Product Change Notice (PCN)

PCN Number: **PCN-0451089R-01**

Product(s) Affected: *PJ-041-SMT-TR*

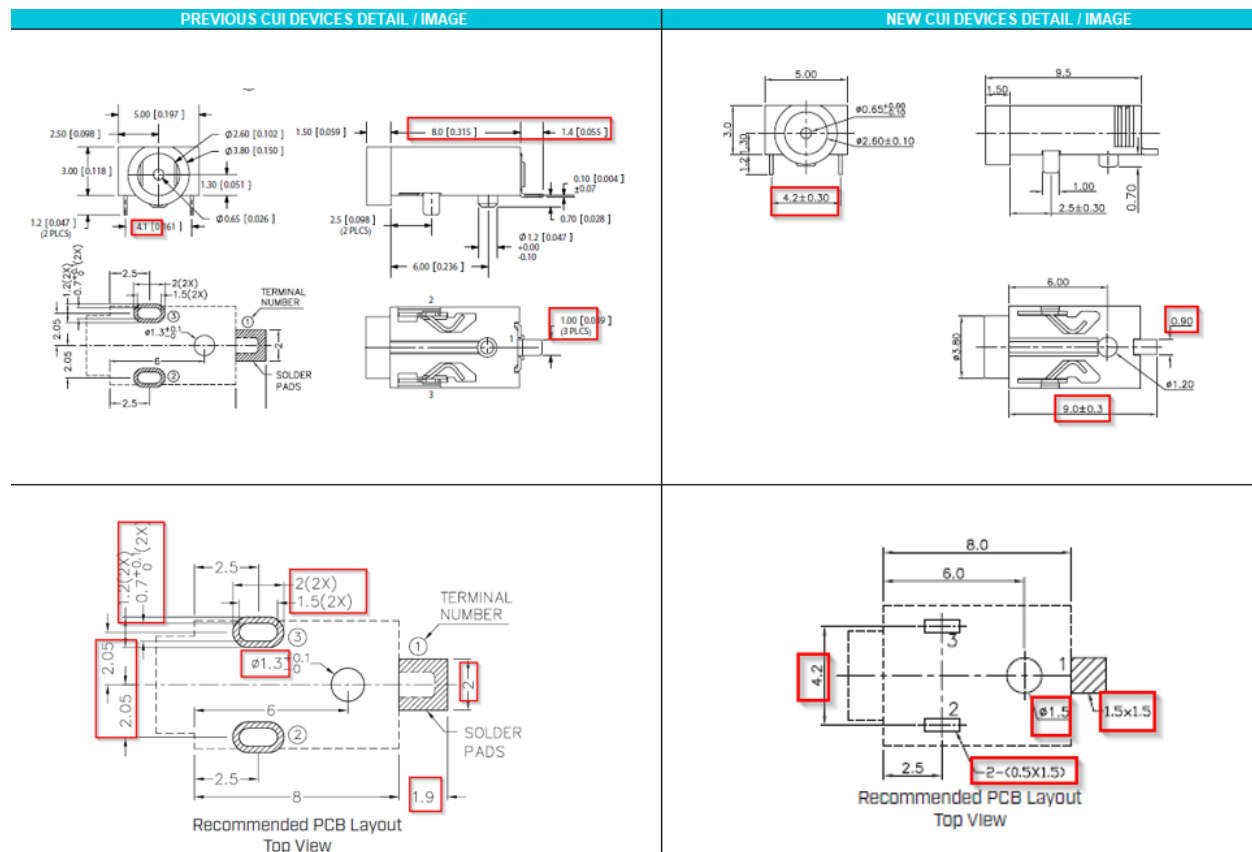
Description of Change: *Minor Housing and footprint differences. Material Change on the housing and terminals. PCB pad sizes, spacings differ. New part will fit on previous footprint. See image Below*

PREVIOUS CUI DEVICES DETAIL / IMAGE			NEW CUI DEVICES DETAIL / IMAGE		
	MATERIAL	PLATING		DESCRIPTION	PLATING/COLOR
center pin	copper	nickel		center pin	bronze silver
terminal 1	brass	silver		terminal 1	bronze silver
terminal 2	copper alloy	silver		terminal 2	SUS301 t=0.20 gold
terminal 3	copper alloy	silver		terminal 3	SUS301 t=0.20 gold
plastic	PAST or equivalent			housing	PA10T (UL94V-0) black
